design drawings for
CONTEMPORARY COMMERCIAL CABINETS
 wayside court at wayland place
 colorado springs, colorado 80915

drawn by
 mfb
 checked by
 mfb
 sheet title
 site / floor plan
 sheet number

Proposed Use: Vehicle Repair Garage

A SITE PLAN / ROOF PLAN
 S101 SCALE: 1" = 20'-0"

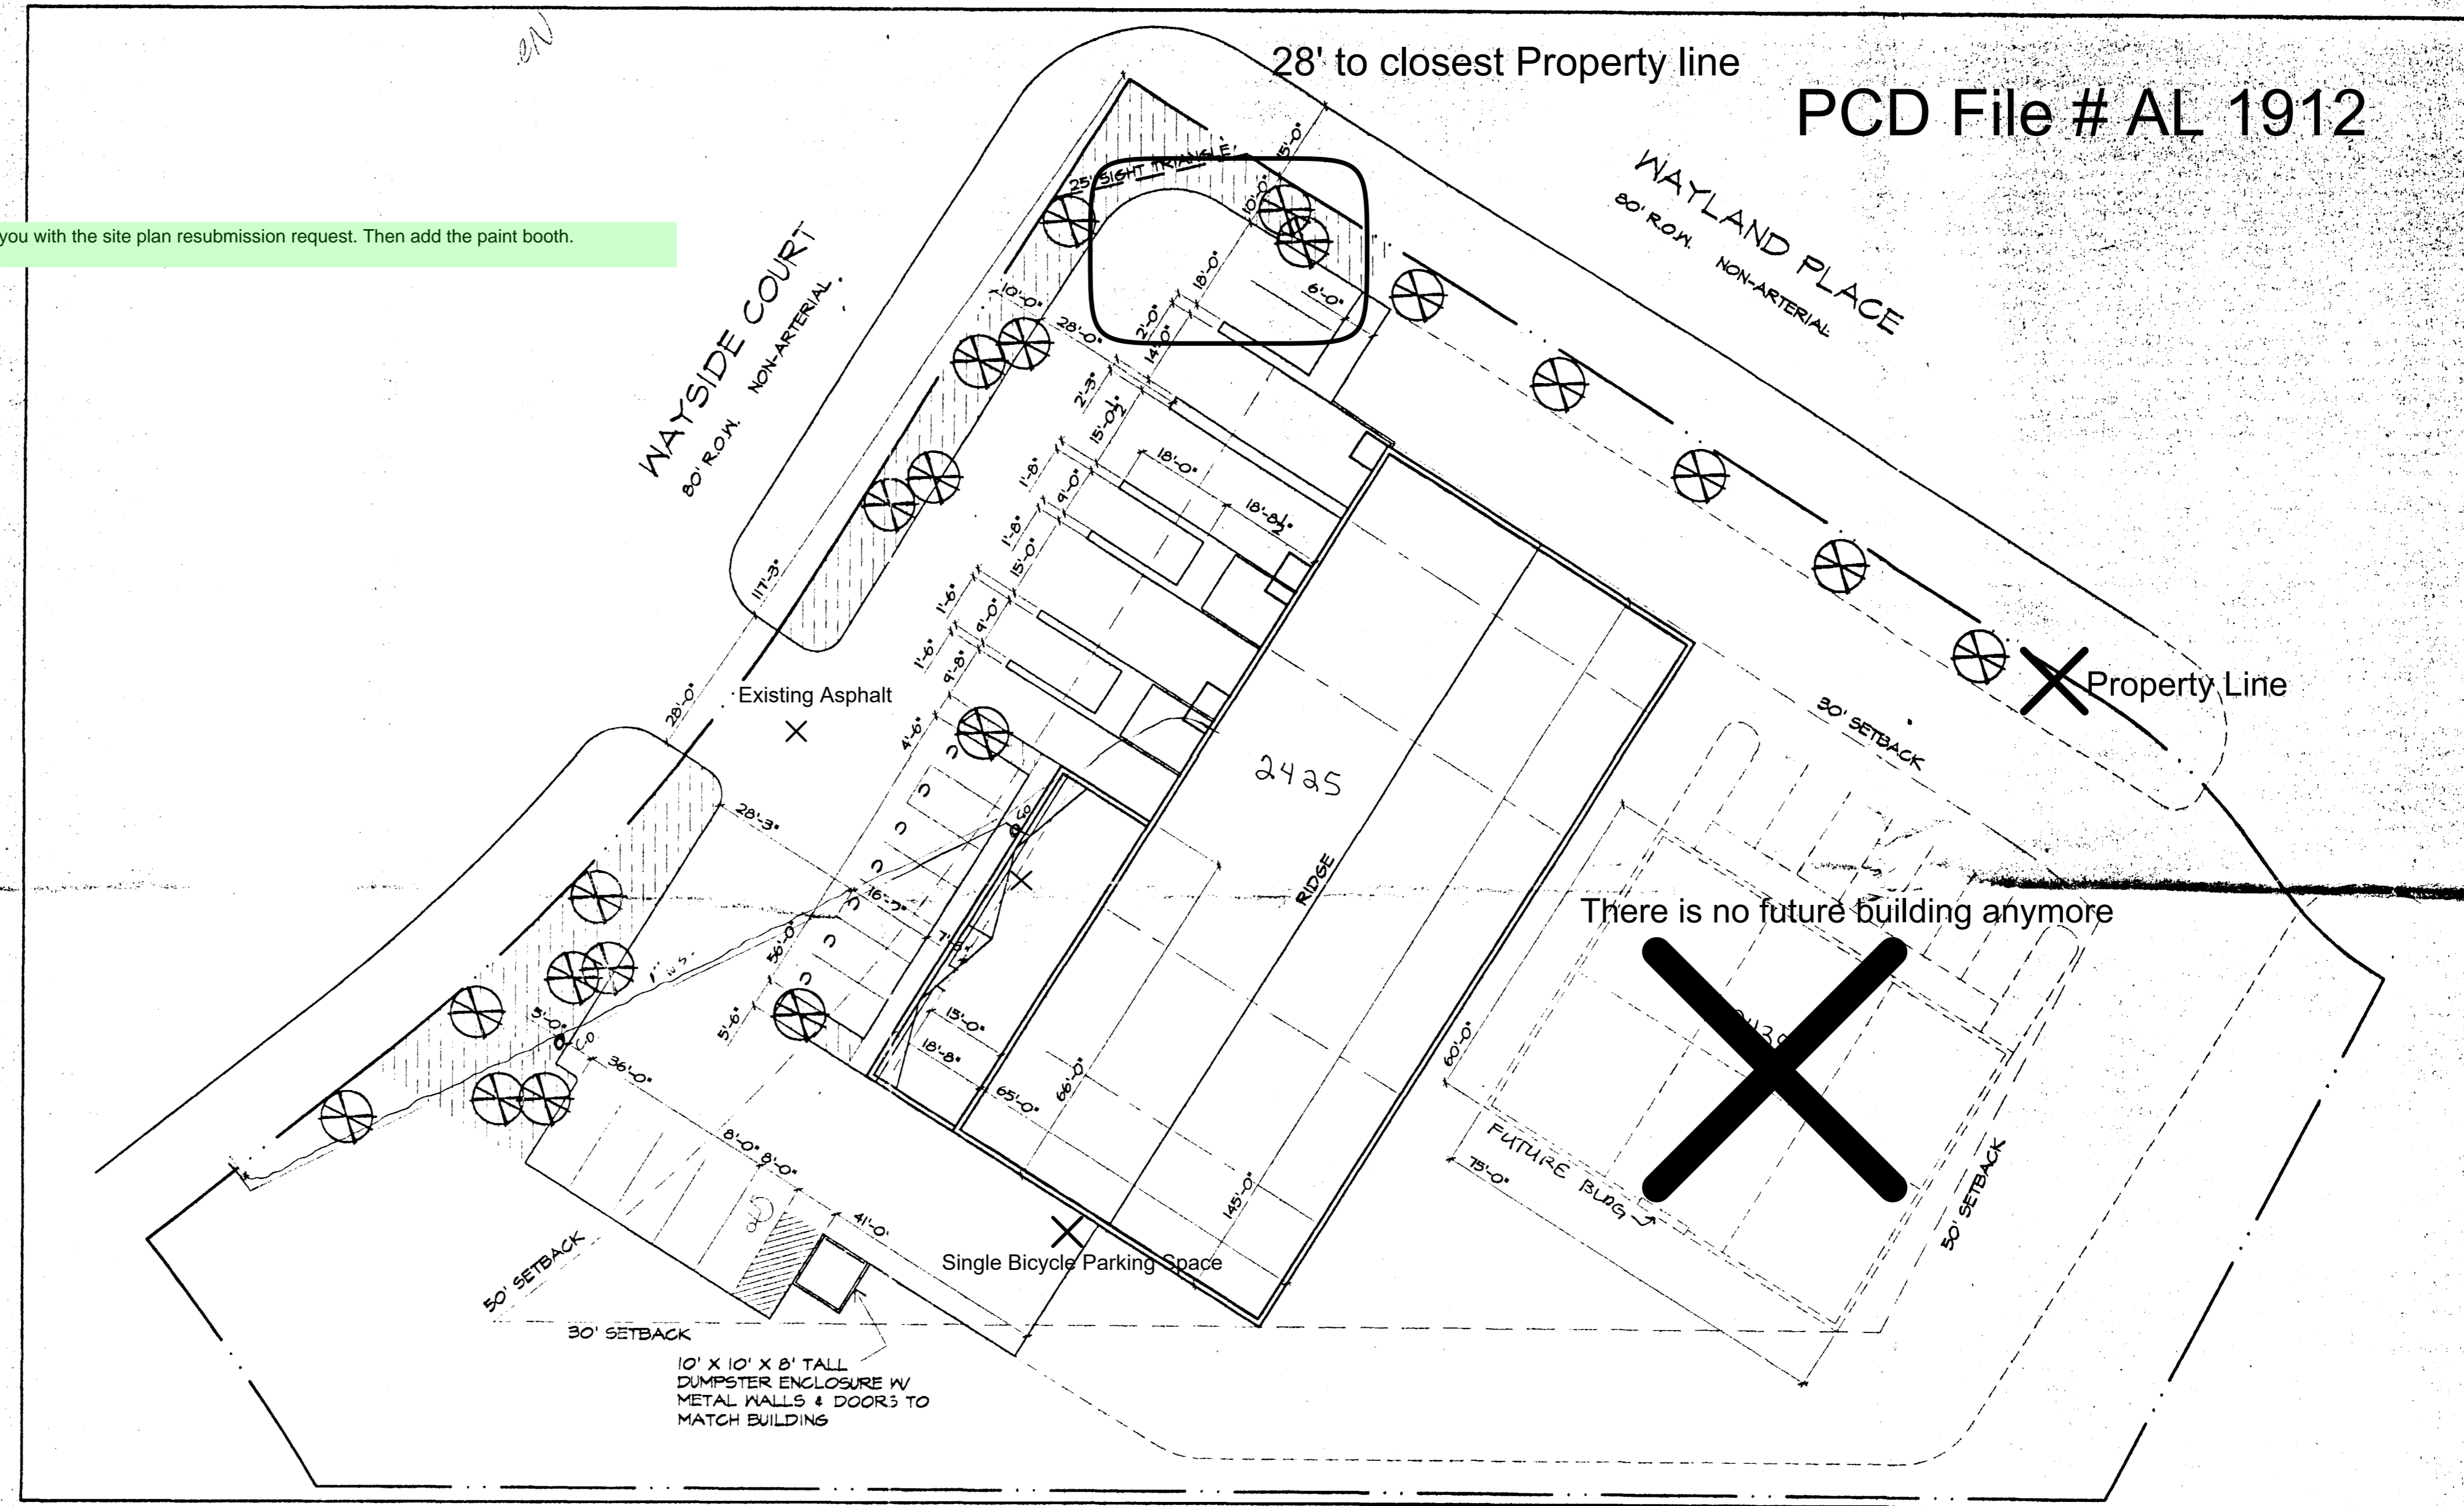
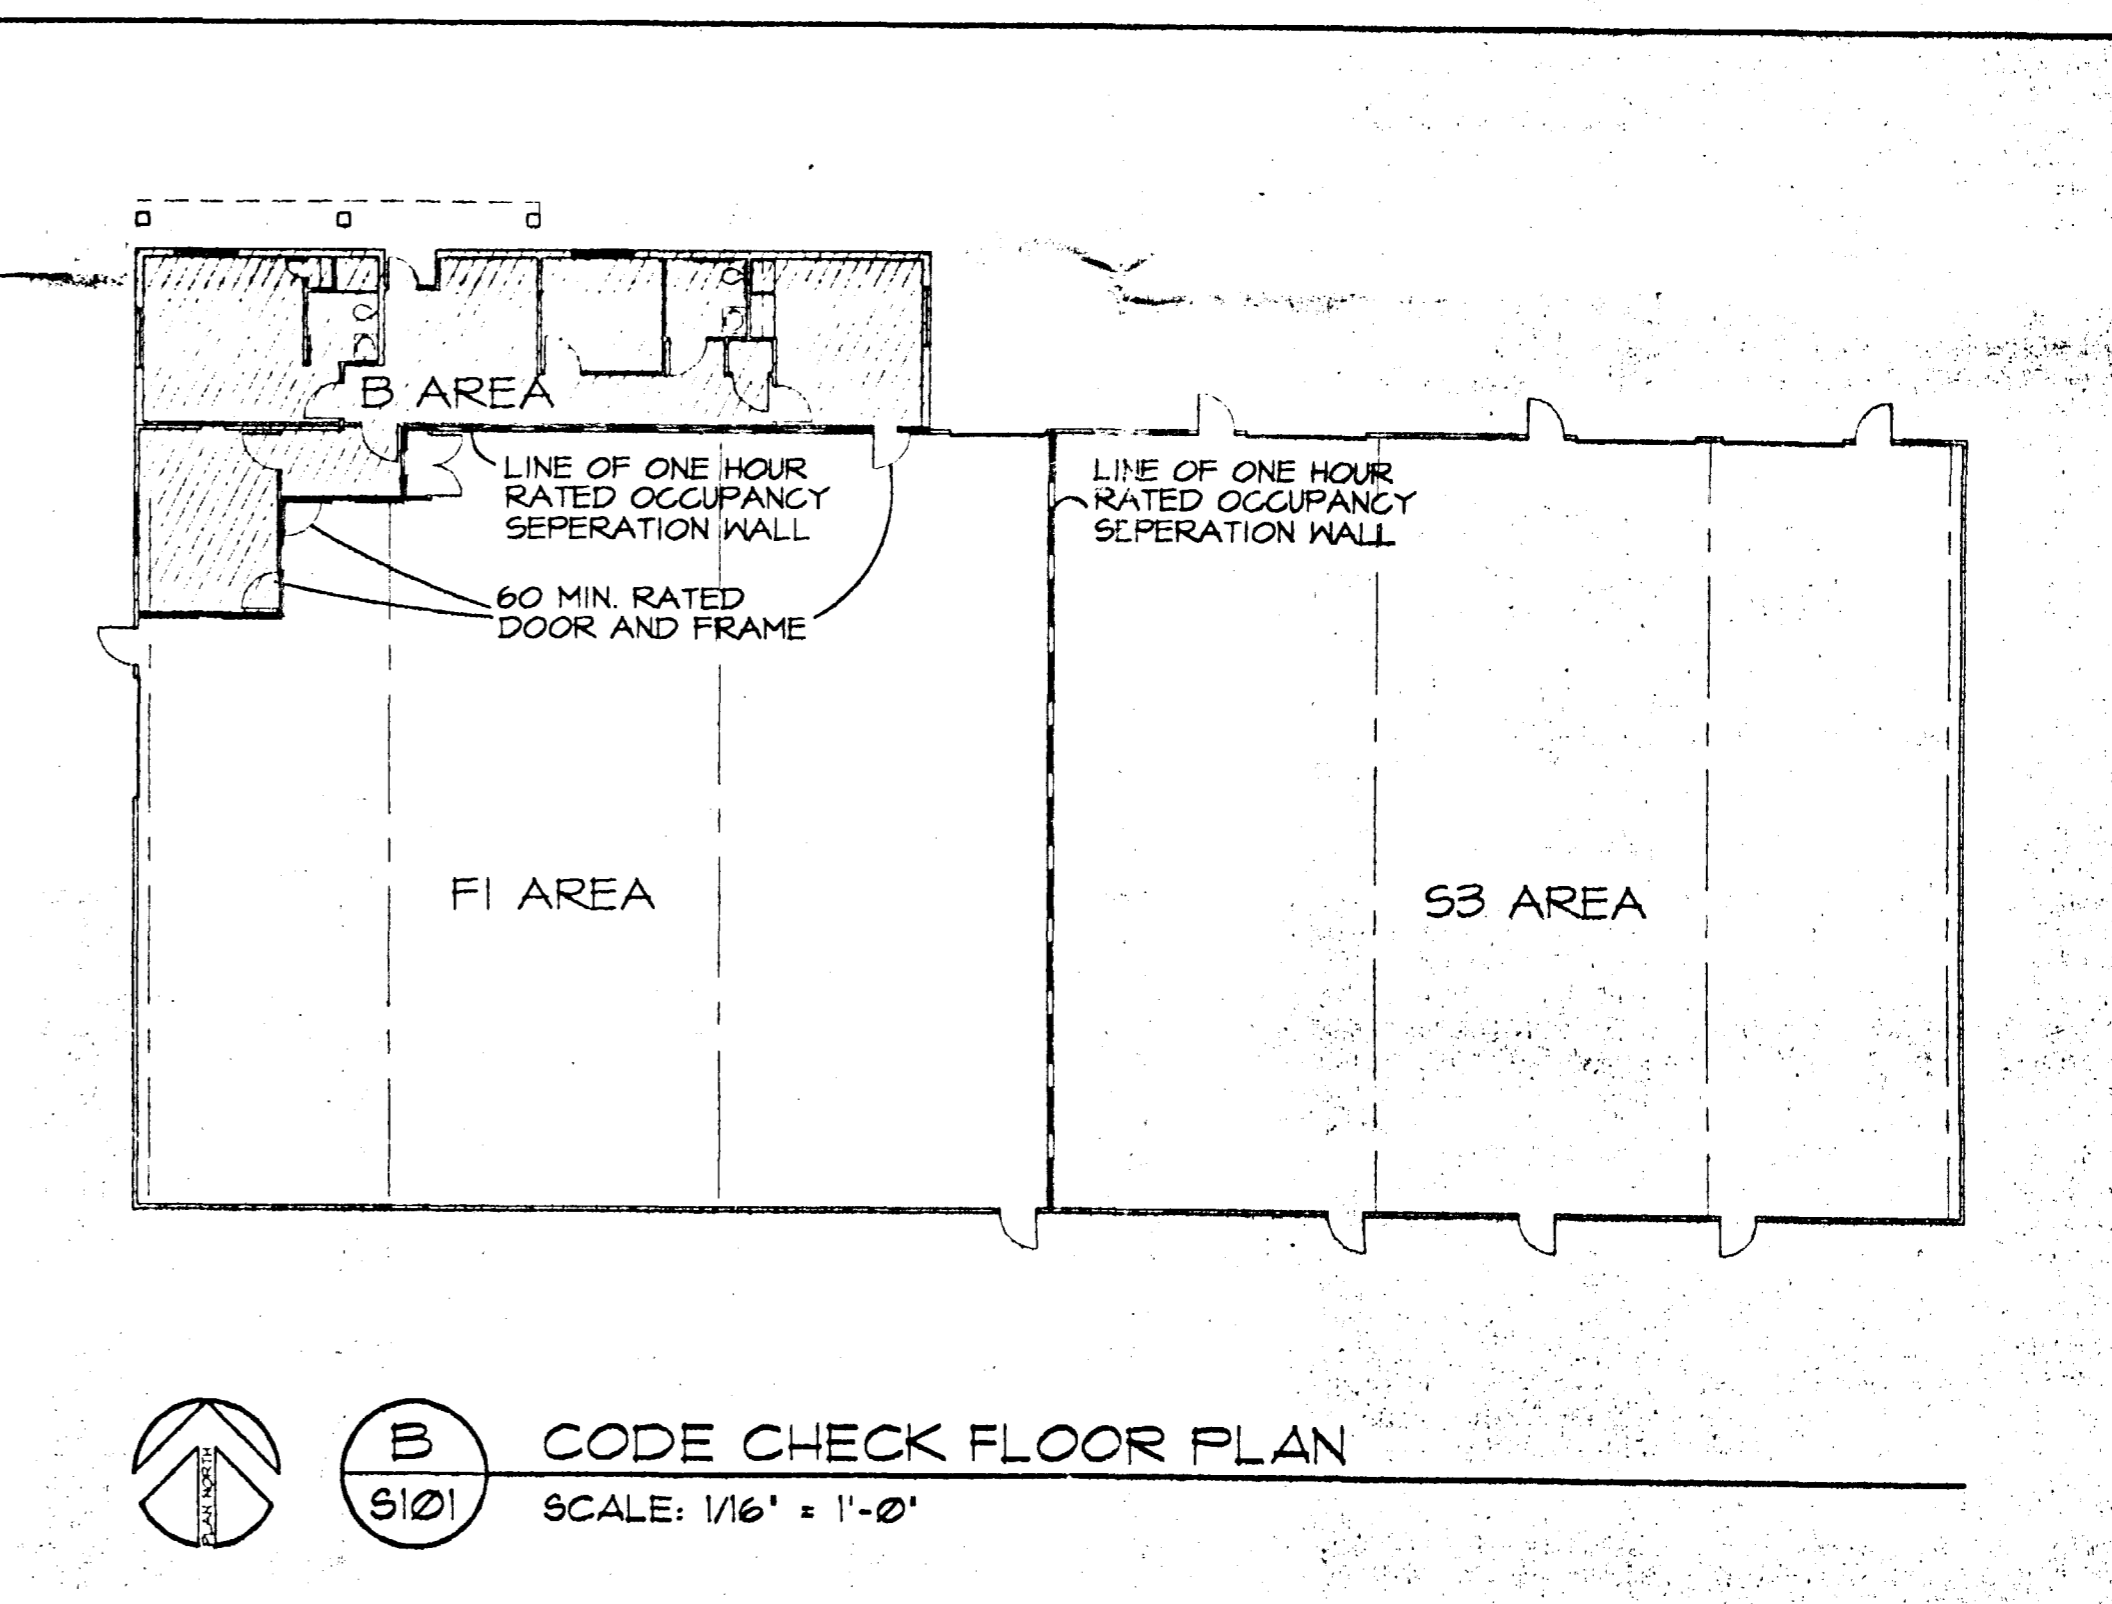
For the Special use site plan, use the revised site plan basemap I sent you with the site plan resubmission request. Then add the paint booth.

Site Data Table

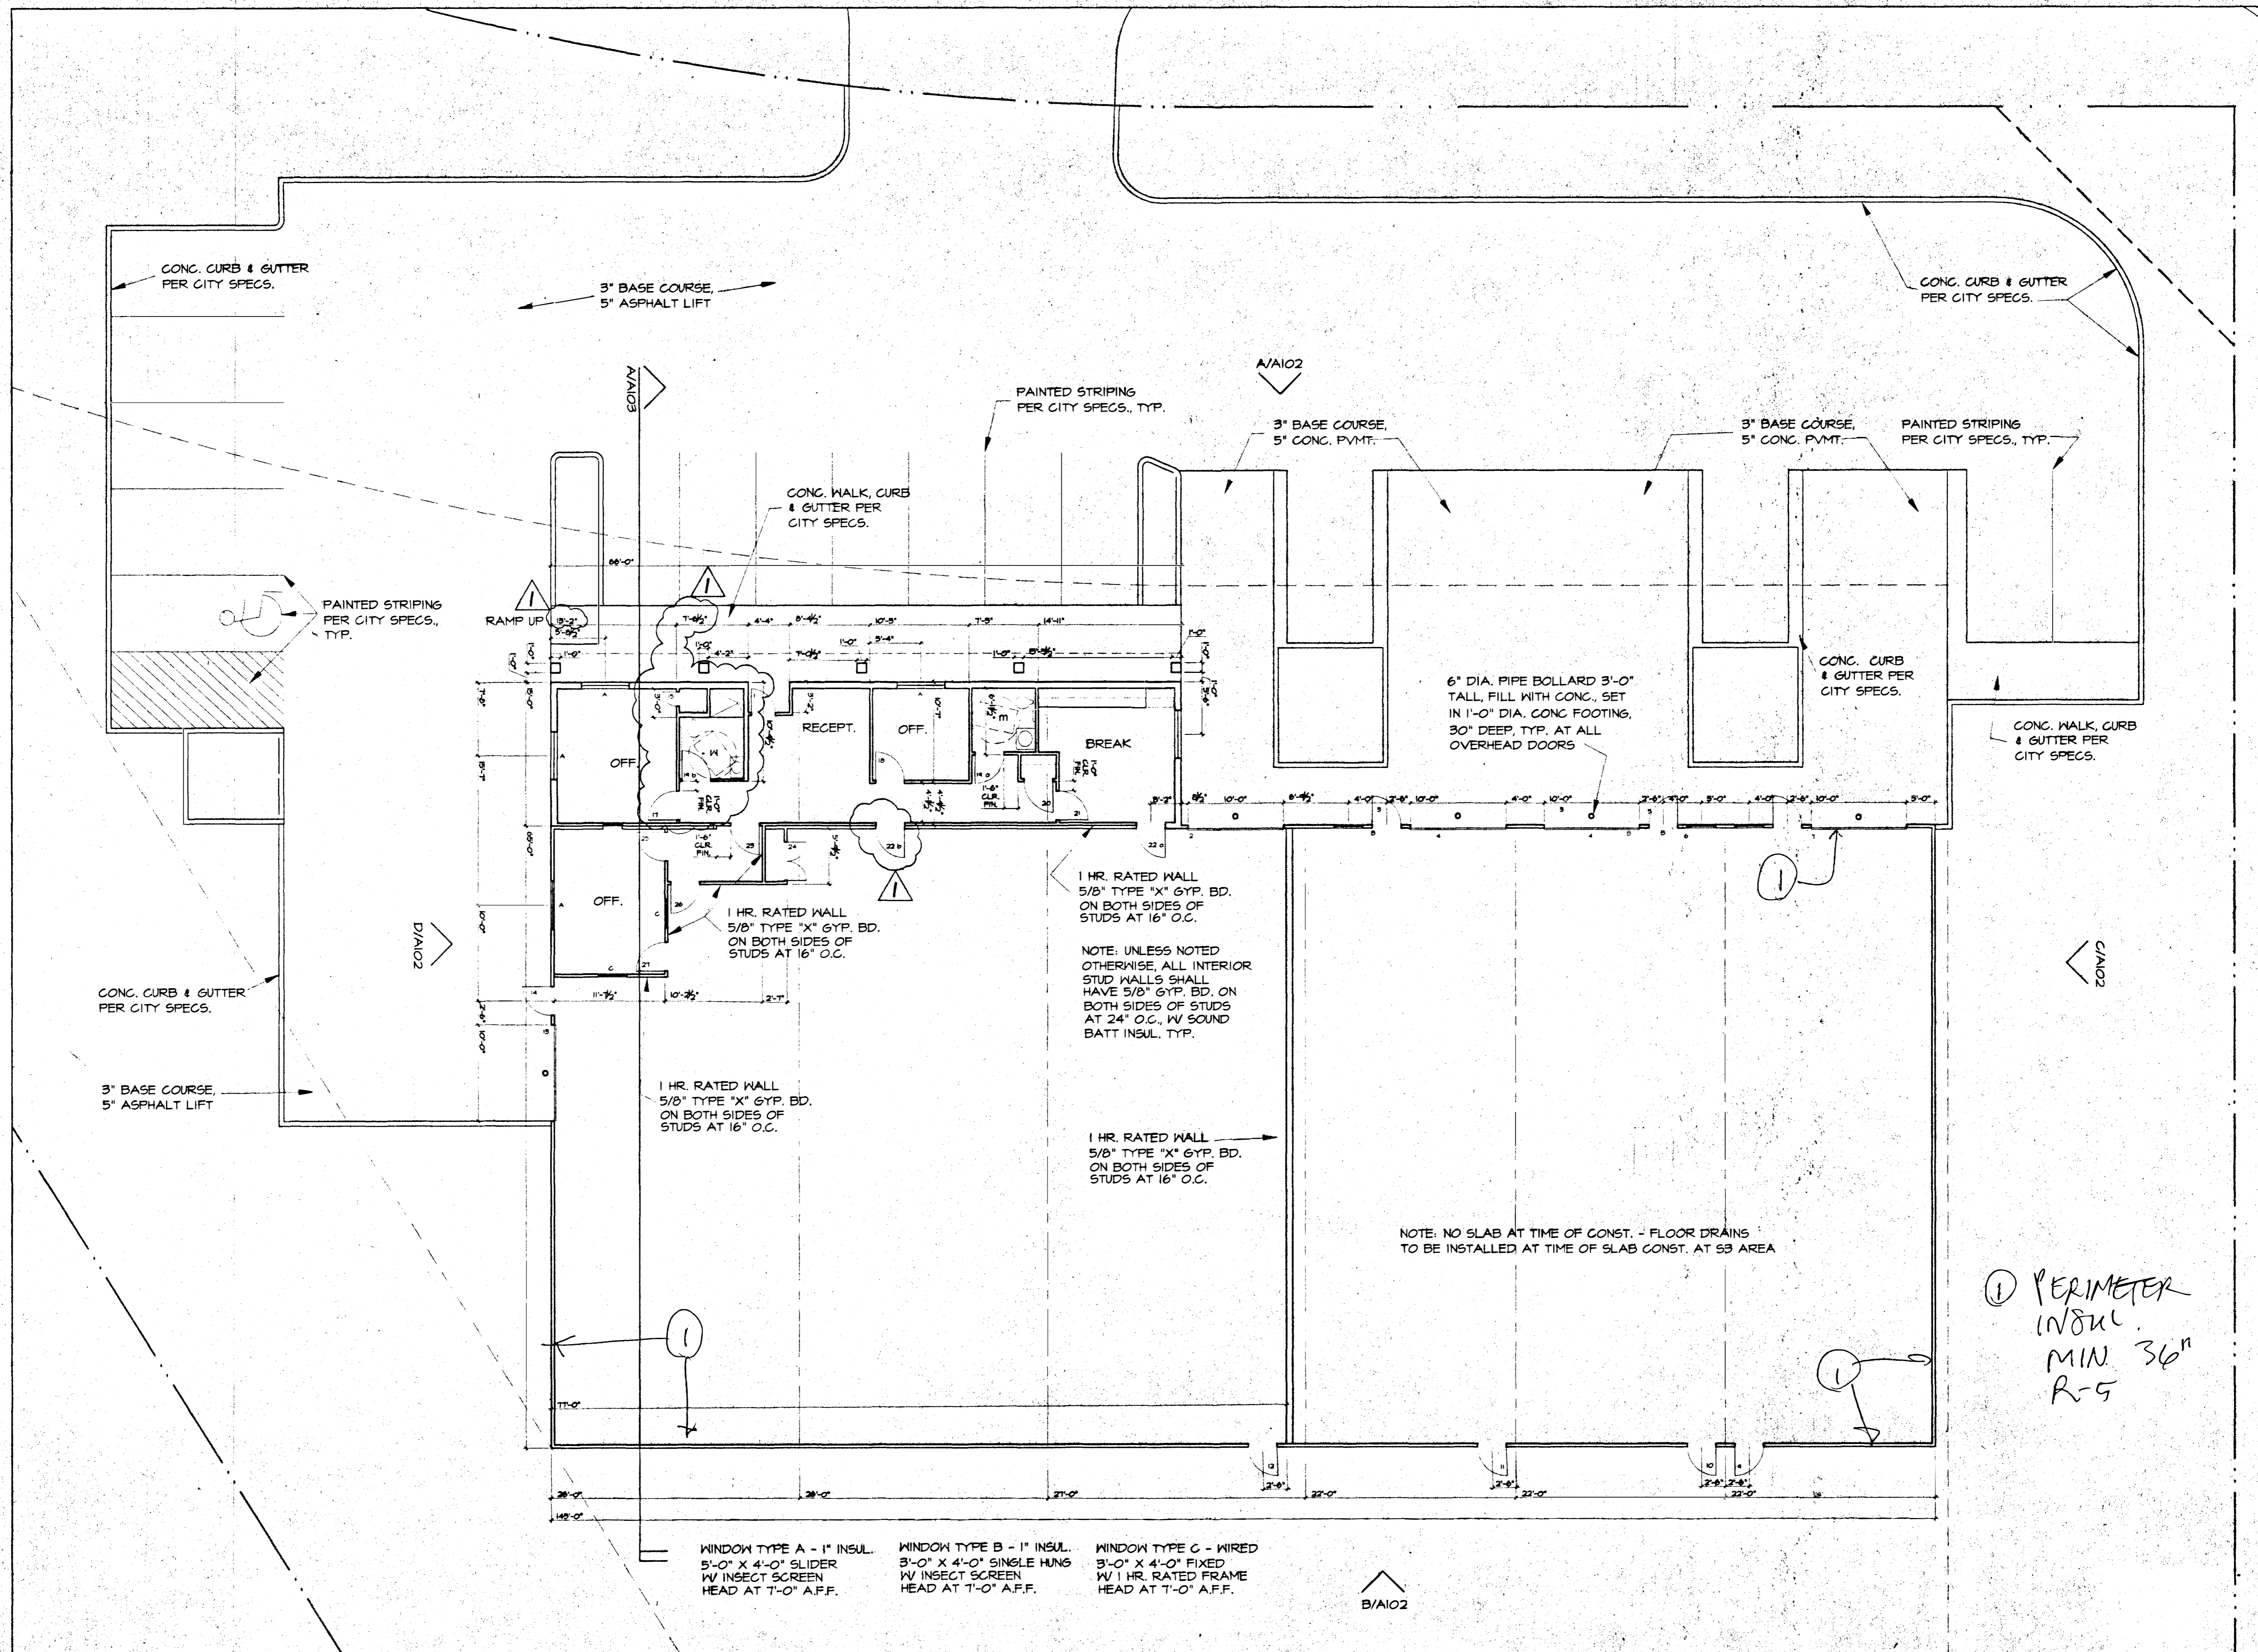
There were 15 spaces on the original blueprints however there is room for 26 parking spaces on the lot.

Single bicycle parking space will be provided indoors.
